PLANNING COMMISSION AGENDA

Tuesday, May 02, 2017
Breckenridge Council Chambers
150 Ski Hill Road

PLANNING COMMISSION MEETING

Proposed Front Facade

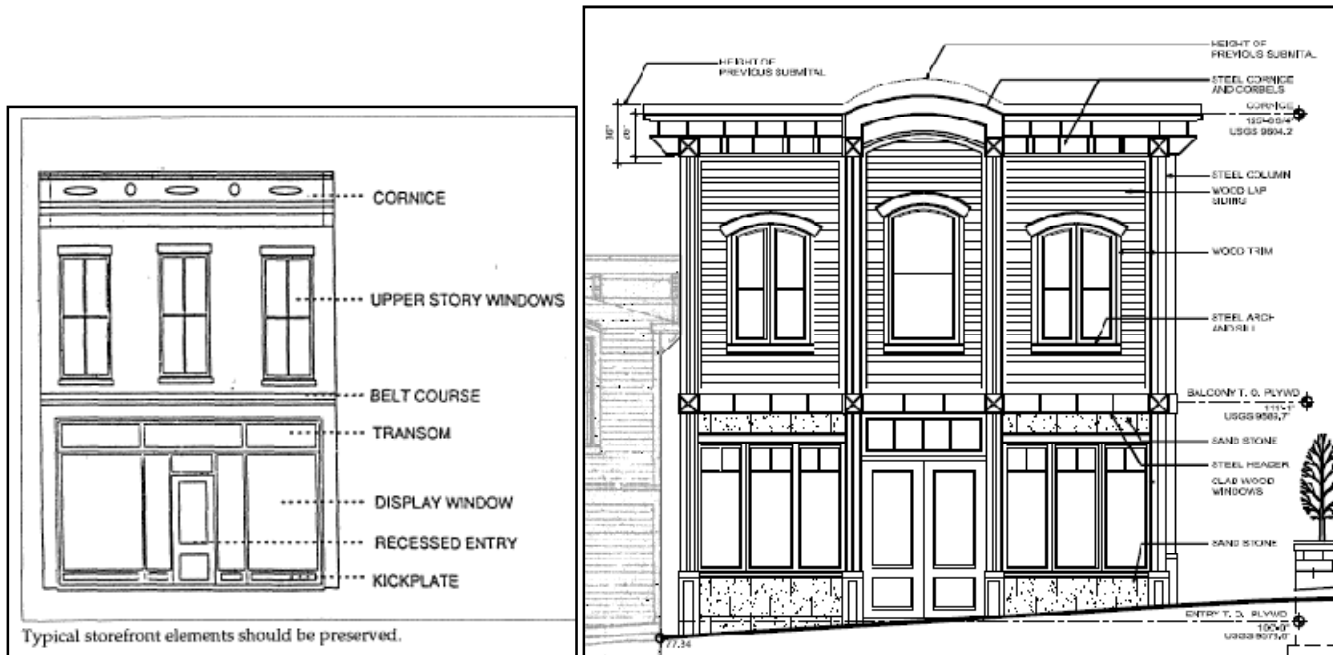
The proposed building shows a recessed entrance store-front design, with storefront windows, sandstone kick plate and sandstone above transom windows on the lower level with wood lap siding with arched windows on the second story. At the Preliminary Hearing the Commission found the design to abide with the Handbook of Design Standards. The design is unchanged from the design the Commission reviewed at the Preliminary Hearing. Staff has no concerns with the form.

Preliminary Hearing

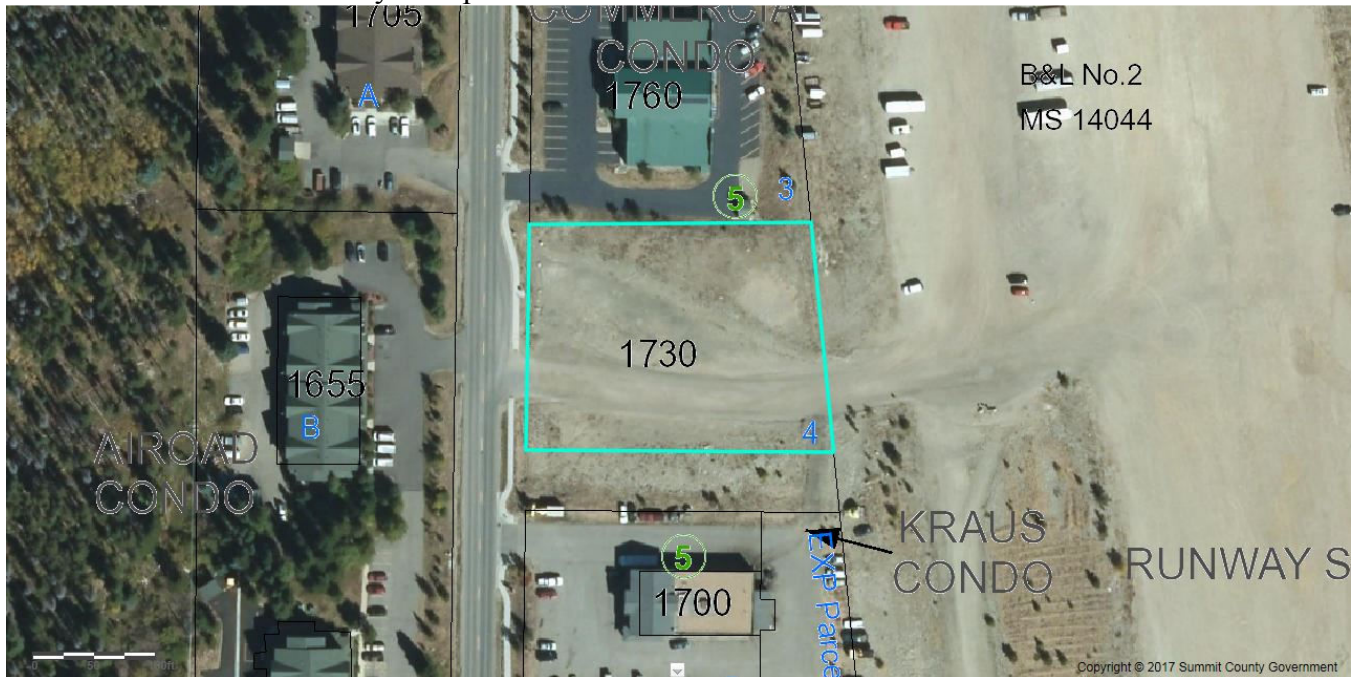
1. The bearing shown on the north boundary of the provided survey has been corrected.
2. The lot line dimension on the west side of proposed lot Lot 3 was previously called out as "93.04" on the provided survey, and has been corrected to "94.04."
3. The lot numbers have been modified from "Lot 4A, Lot 4B, Lot 4C" to "Lot 1, Lot 2, Lot 3" on the proposed plat, plat notes, and survey. Staff has reflected this change in the staff report.
4. Proposed plat note #5 has been updated to include a reference to a reception number for the Satellite Place Subdivision Declarations.

- Proposed plat note #4 has been updated to clarify that the “no portions of [The 10’ Snow Stack and Utility Easement] may be used for storage of snow from Lots 1, 2 or 3.” per Commissioner Mathews-Leidal’s comment at the Preliminary Hearing (easement runs along Airport Road).

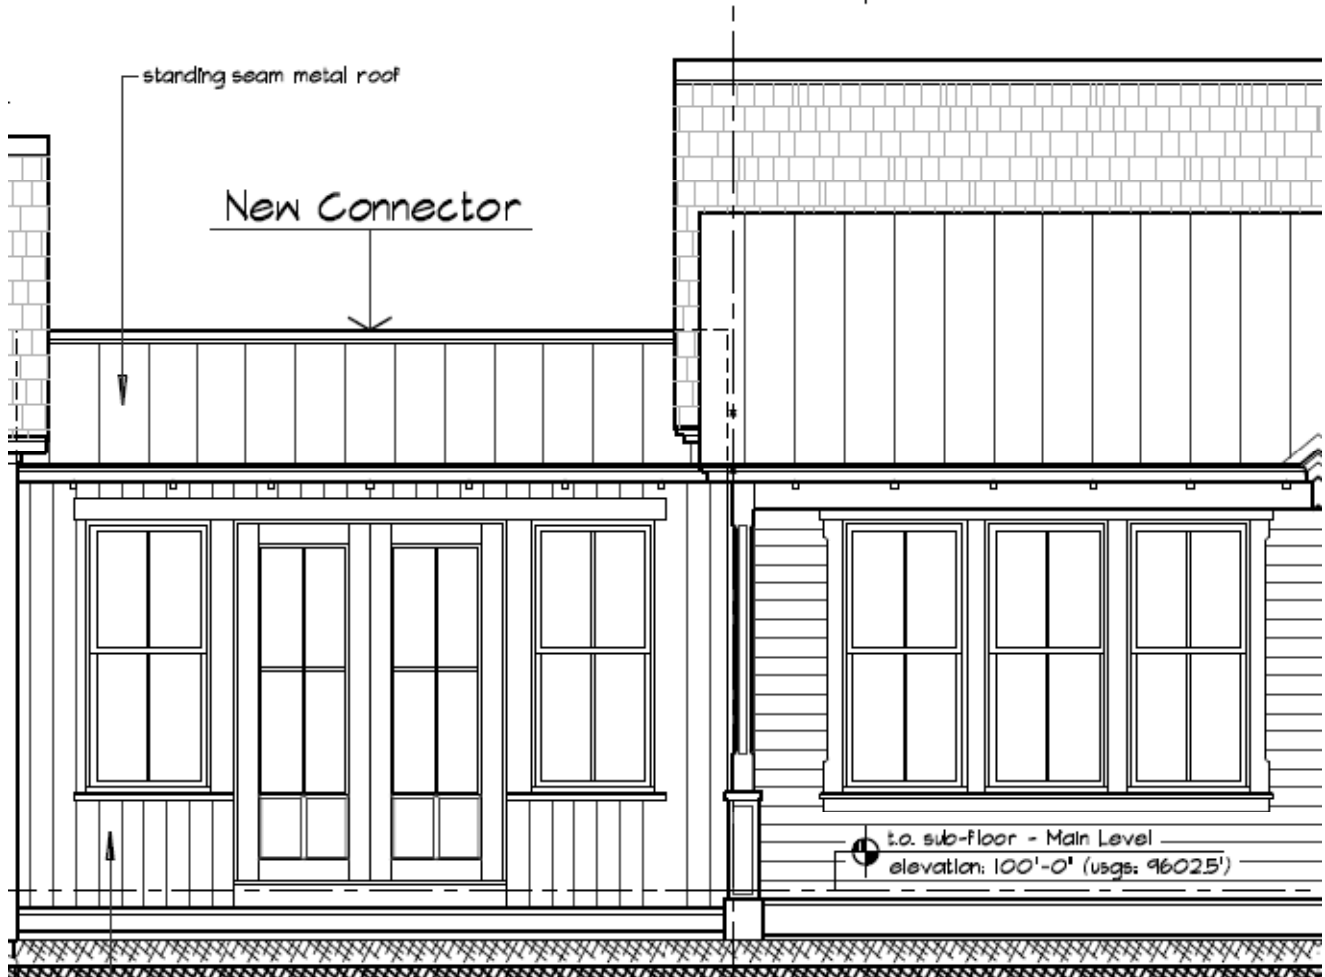
The historic portion of the building is separated from the larger addition with a connector. The drawing shows a concrete patio and no plantings in front of the connector that separates masses as seen from the ROW. Staff believes that landscaping added here could be used to reduce the perceived scale where
